ECN/PCN No.: 1368

Product Description: Low Profile Shielded SMD Chip Power Inductor	Abrakon Part Number / Part Series: ASPI-0310FS Series	<input type="checkbox"/> Documentation only <input checked="" type="checkbox"/> Series <input checked="" type="checkbox"/> ECN <input type="checkbox"/> Part Number(s) <input type="checkbox"/> EOL
Affected Revision: E	New Revision: F	Application: <input type="checkbox"/> Safety <input checked="" type="checkbox"/> Non-Safety

Recommended Land Pattern

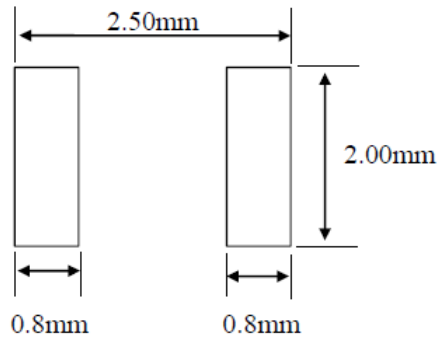
Moving to different production line. Uncovered erroneous pad dimensions in previous datasheet. Removed the -T2 suffix and replaced with -T.

Recommended Land Pattern

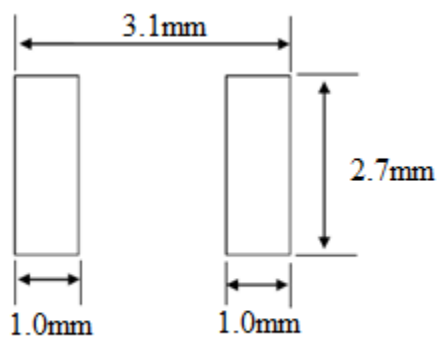
Pad dimension correction may cause issues with existing designs. Ensure design engineer reviews pad dimensions in latest datasheet.

Packing

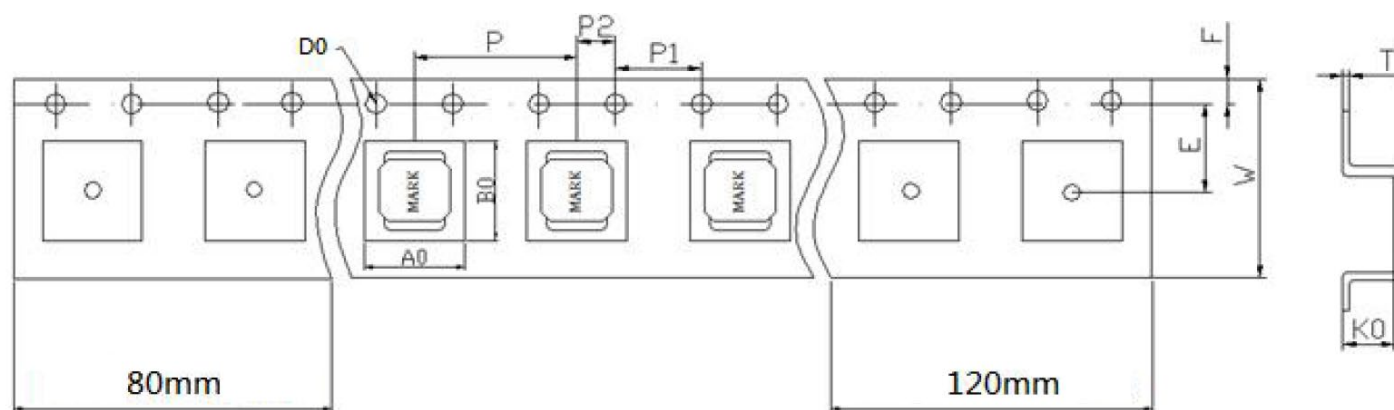
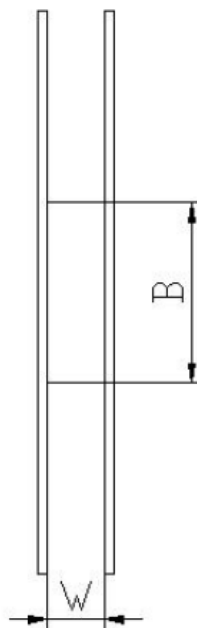
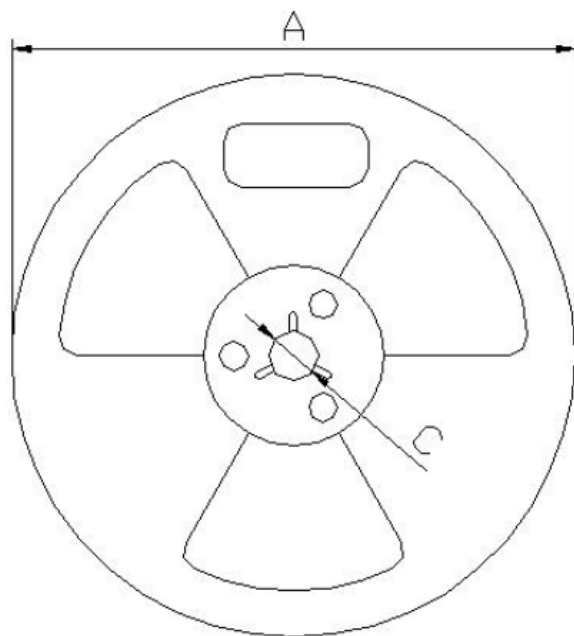
T: 2,000pcs / reel
